STAFF REPORT  
KETCHUM PLANNING AND ZONING COMMISSION  
REGULAR MEETING OF AUGUST 10, 2021

**PROJECT:** The Lofts at 760

**FILE NUMBER:** P 21-043

**APPLICATION TYPE:** Preapplication Design Review

*Figure 2: Parking Allocation for Off-Street Parking*

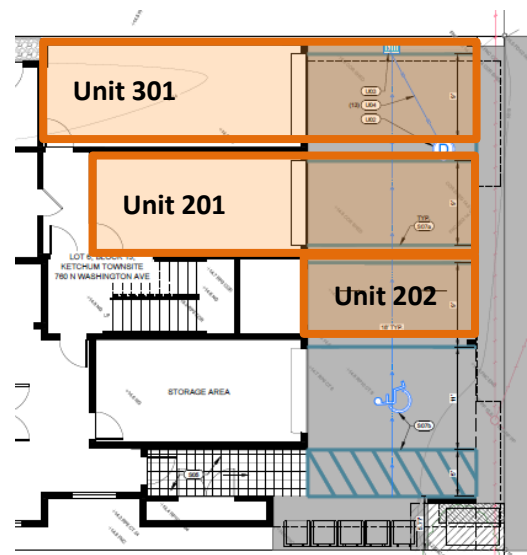
Although there are 6 parking spaces on site, the tandem configuration of the two garage spaces, requires that the garage and adjacent surface space be dedicated to the same unit. As such, there is no off-street parking for the commercial unit. In the Community Core, for 5,500 square foot lots, if the parking requirement results in more than four spaces, on-street parking adjacent to the building can be used to meet the parking requirement for non-residential uses (KMC §17.125.050.D) provided that four off-street spaces are provided first. The subject property is 5,501 square feet and the project is providing more than four off-street parking spaces, therefore, on-street parking can be used to meet the requirement for the commercial unit.

Additionally, there is a storage unit proposed in front of the ADA space. The initial application designated this as a garage, however, staff indicated to the applicant that this could not be a parking space as the ADA space obstructs use of the garage for parking. As the project moves forward, staff recommends restrictions on the use of that space be indicated on the preliminary and final plats to ensure no future use of that area for parking.

**LAYOUT, GRADING, AND DRAINAGE PLAN**  
**760 N WASHINGTON AVENUE**  
 LOCATED WITHIN SECTION 13, T.4 N., R.17 E., B.M., CITY OF KETCHUM, BLAINE COUNTY, IDAHO  
 PREPARED FOR GALENA PEAK PARTNERS / HOLLIS RUMPELT ARCHITECTS

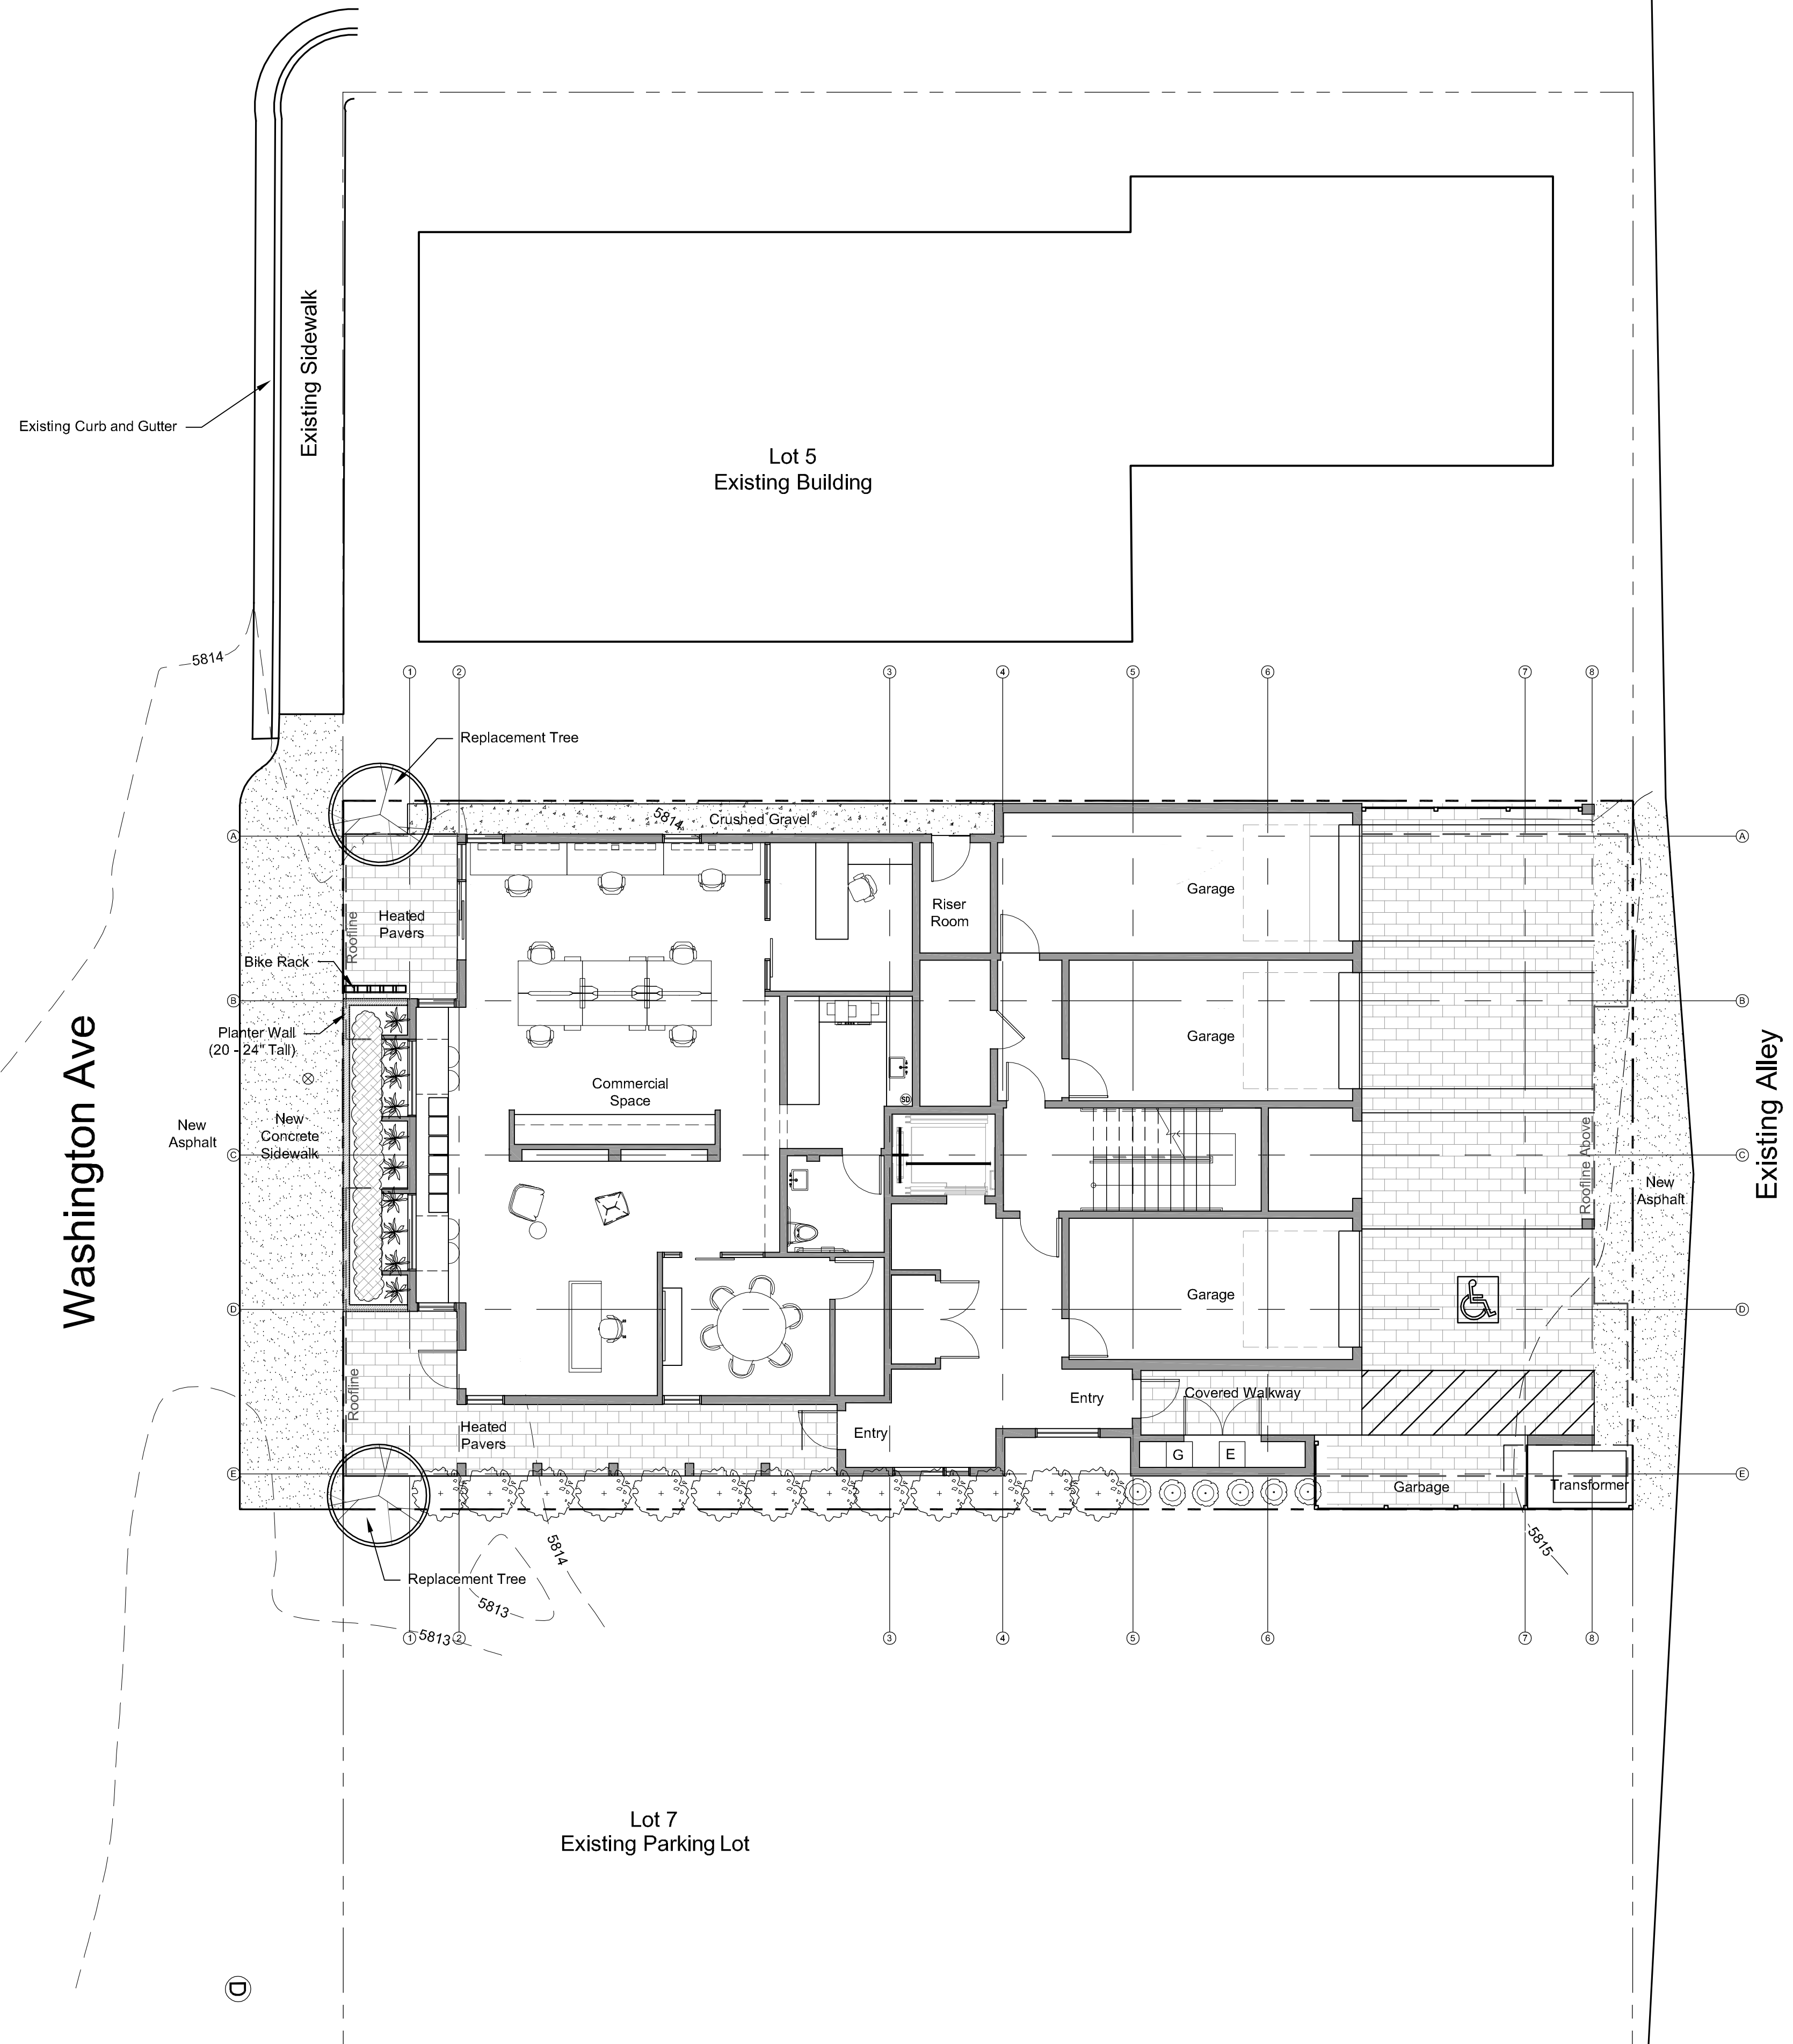
The project proposes a total of six spaces on site, two garage spaces, three surface spaces, and one ADA space all accessed from the alley (see Sheet C1.0 of Exhibit B). Below is an overview of the parking required and the proposed compliance of the project. As shown in the table, the project proposes to meet the parking requirements for the commercial unit with on-street parking.

Sheet No:  
L2

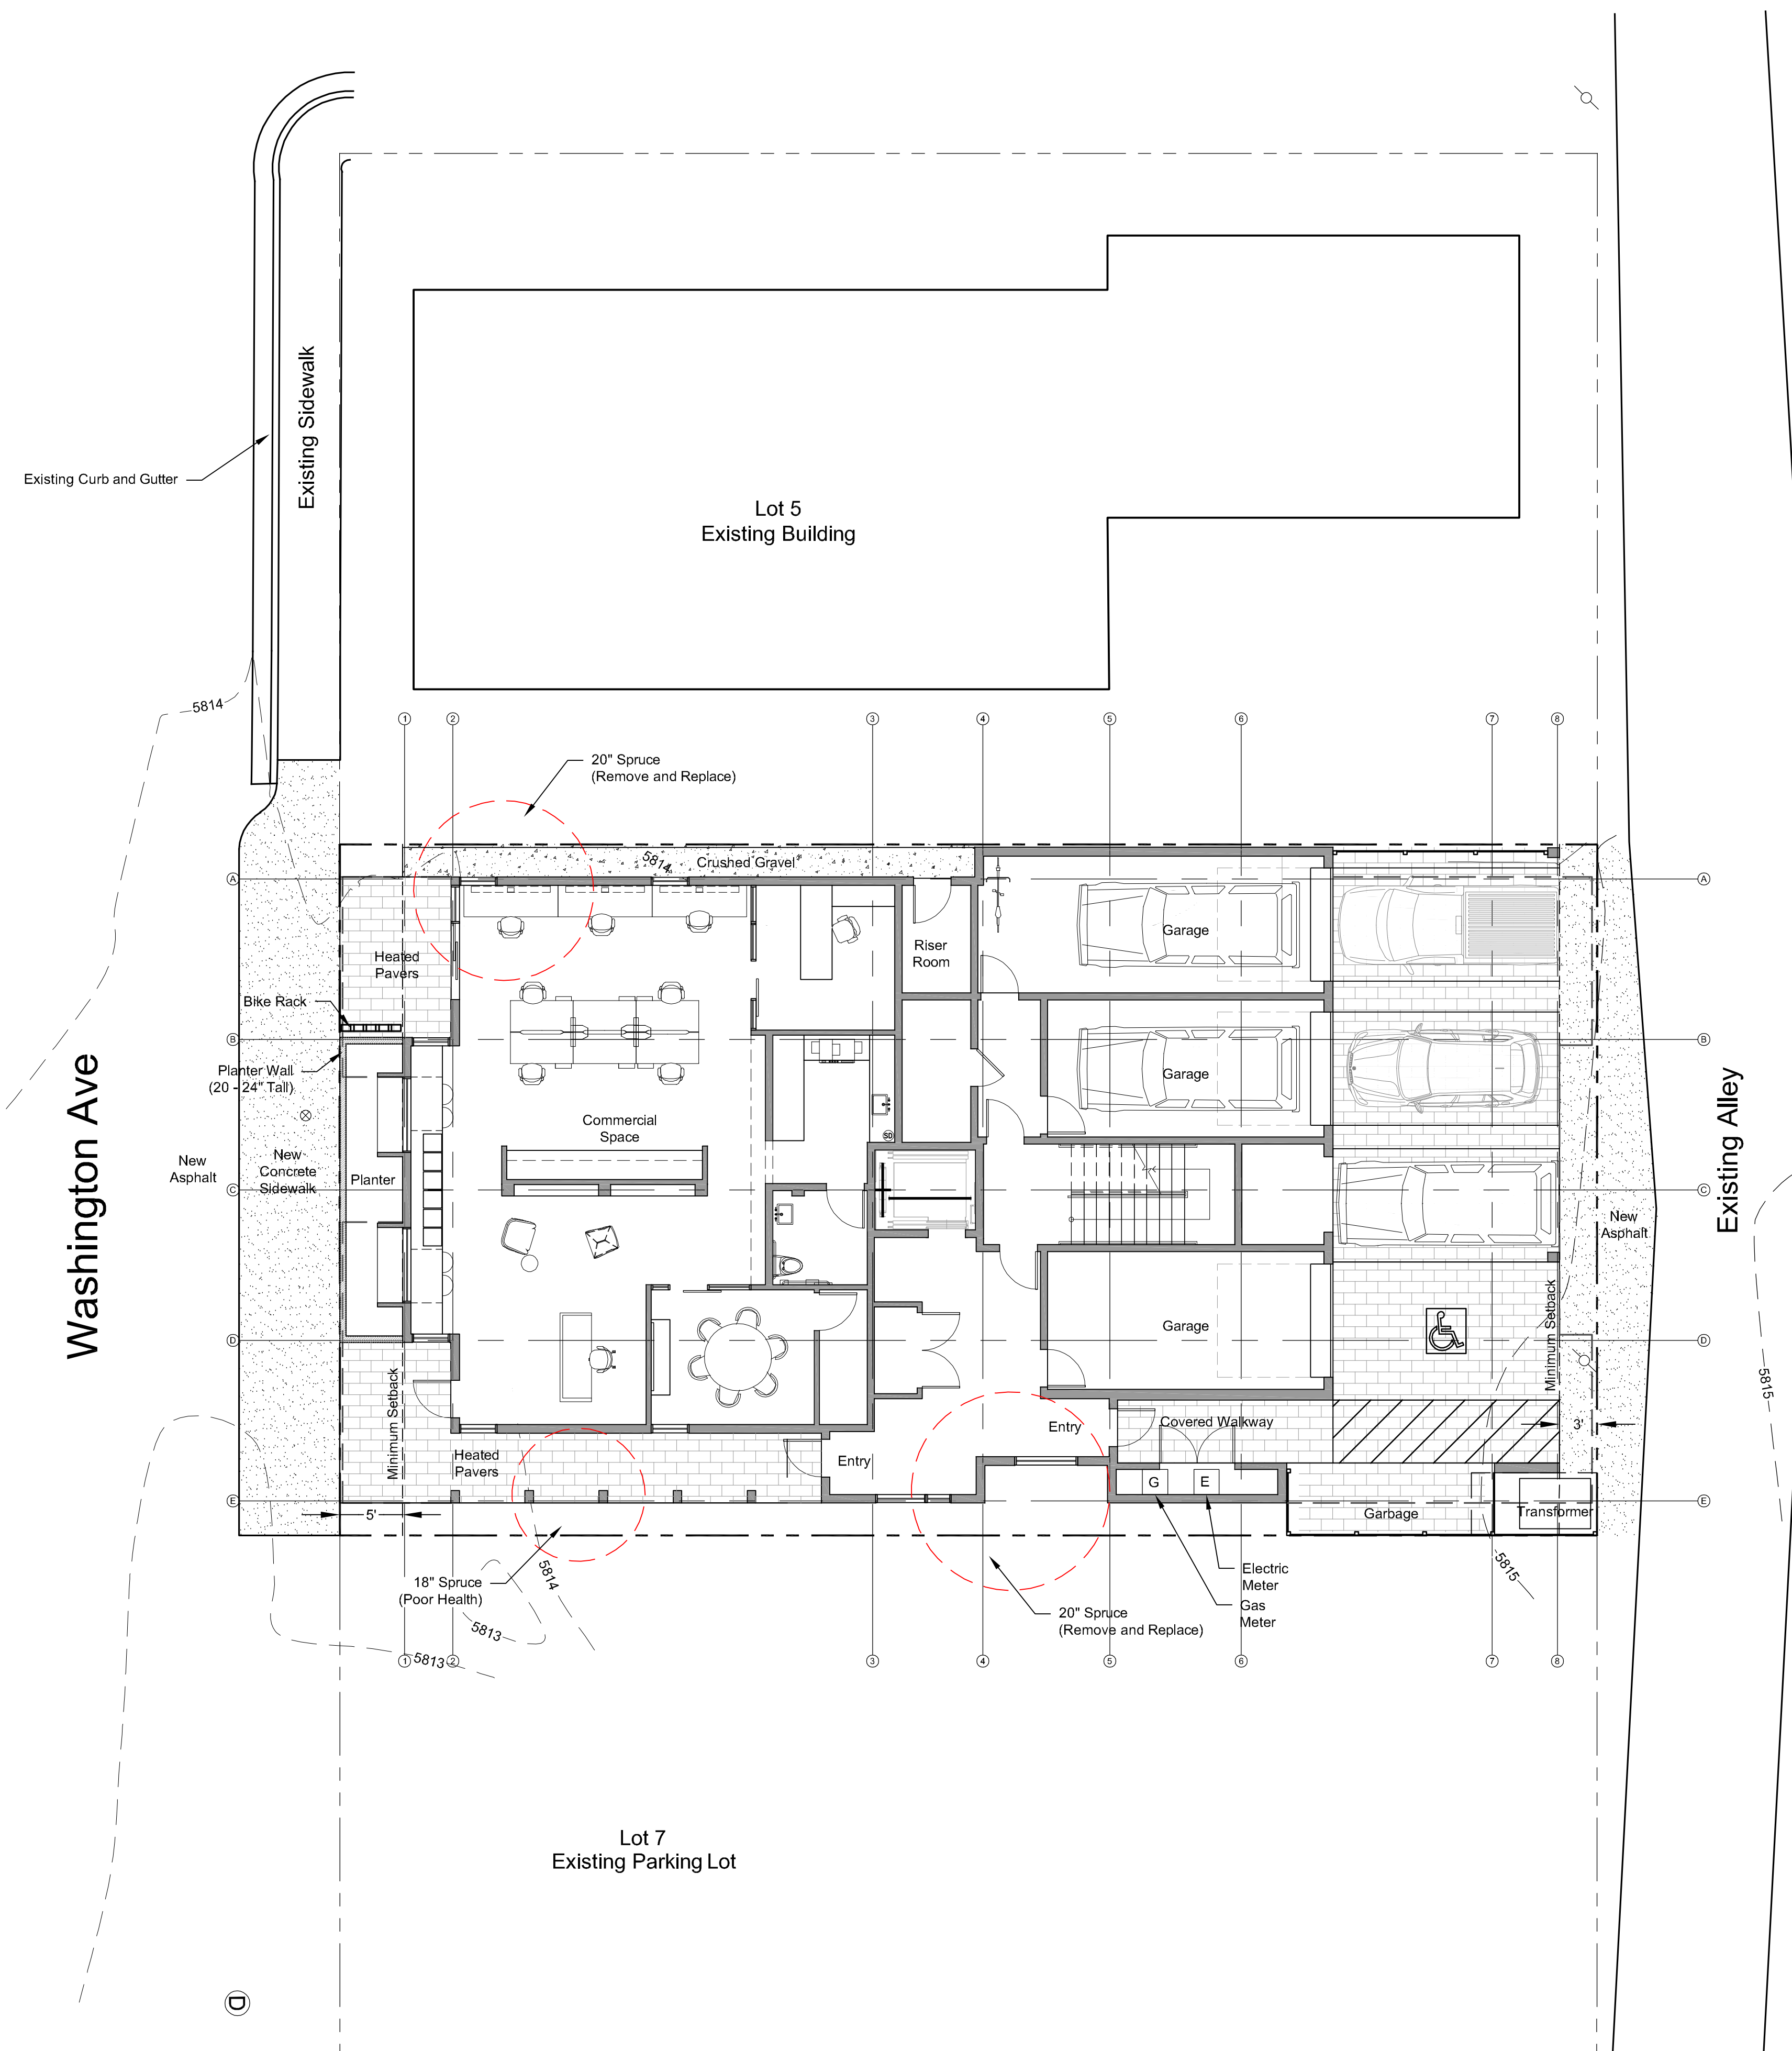
• *Section 17.96.070.I – Landscaping* – Per the site visit on June 24, 2021 with the City Arborist, two replacement trees are required for the proposed project. Staff believes the landscape plan meets the requirement for replacement trees with the two maples shown on Sheet L2.
